Item ID: D119-646-141 **Accept** ***N900040100*** **Setup Start *NS1***
Revision ID: URF 15-560 **Stop *NS2***
Item Name: AW119 Replacement Skidtube with Standard Wearplates & Wearpads, Fits LH & RH
Start Date: 2/1/2017 **Start Qty:** 1.00 ***1*** **Cust Item ID:**
Required Date: 2/8/2017 **Req'd Qty:** 1.00 ***1*** **Customer:**
Reference:

DRAWING NO. **D3887** REV. D
SHEET 1 OF 8
TITLE **A119 STD SKIDTUBE ASSY** SCALE NTS

DRAWING NO. D3887	TITLE A119 STD SKIDTUBE ASSY	REV. D	DART AEROSPACE USA, INC. ENGINEERING ORDER		D.E.O. NO. D3887-D-1	SHEET NO. SHEET 1 OF 3	SCALE NTS
DRAWN AJS		CHECKED		MFG. APPR.	APPROVED	DE APPR.	
DATE 16.11.08		DATE		DATE	DATE	DATE

D3887-041 STANDARD SKIDTUBE ASSY WITH WEARPAD
(MAKE FROM D3887-11)

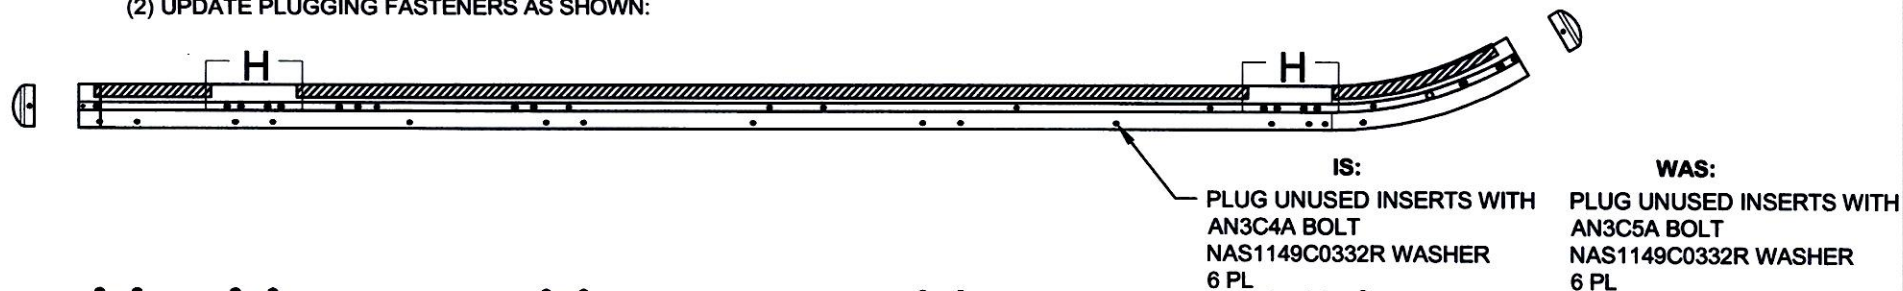
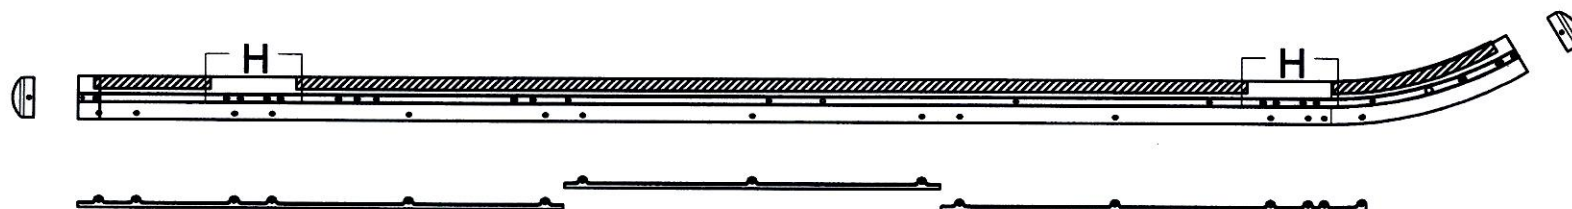
SHEET 2: (1) ADD DETAIL H
(2) UPDATE PLUGGING FASTENERS AS SHOWN:

D3887-043 STANDARD SKIDTUBE ASSY WITH WEARPLATE
(MAKE FROM D3887-11)

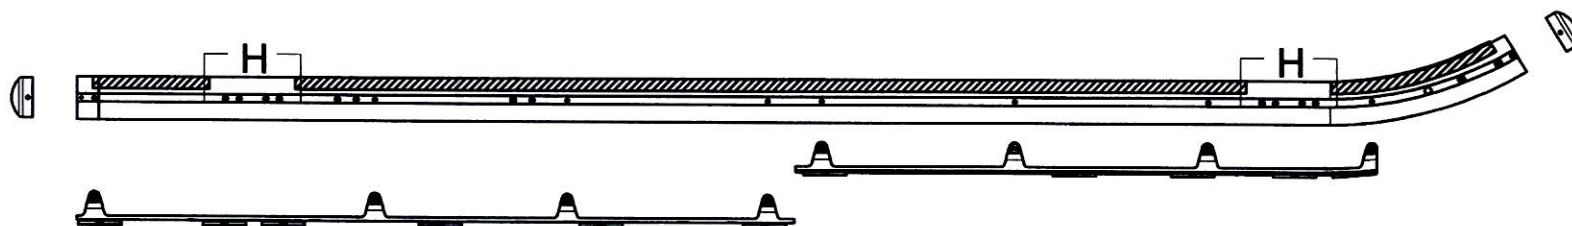
SHEETS 3 AND 4 ADD DETAIL H

DETAIL H

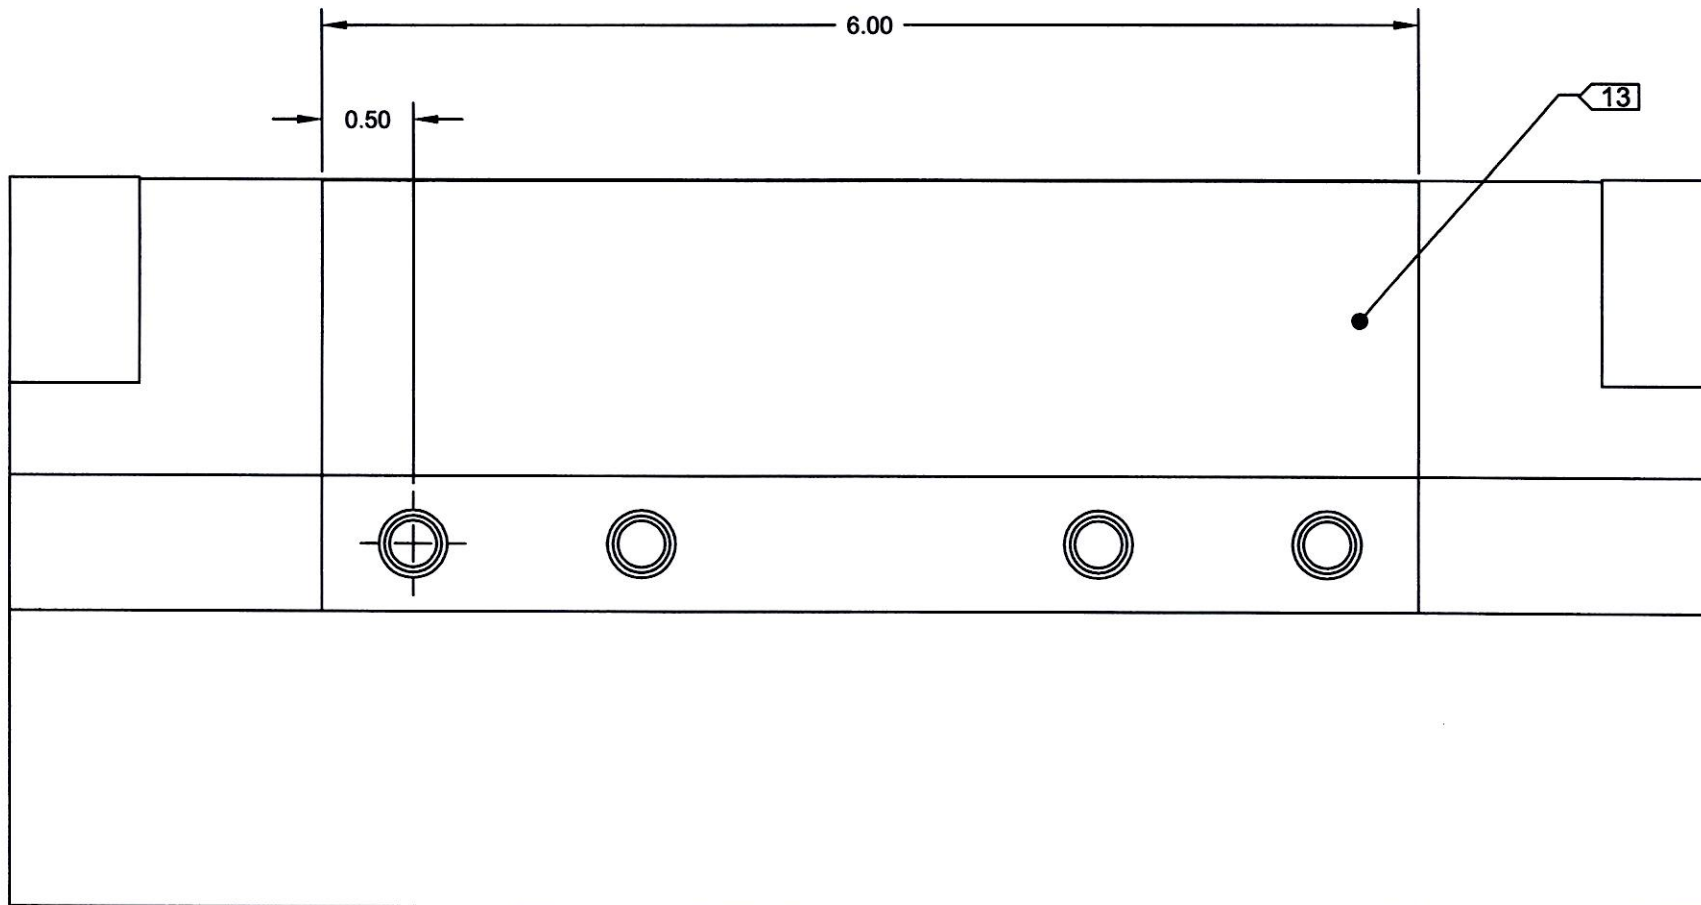
SHEET 7 ADD DETAIL H TO THE FACE OF DRAWING AS SHOWN:
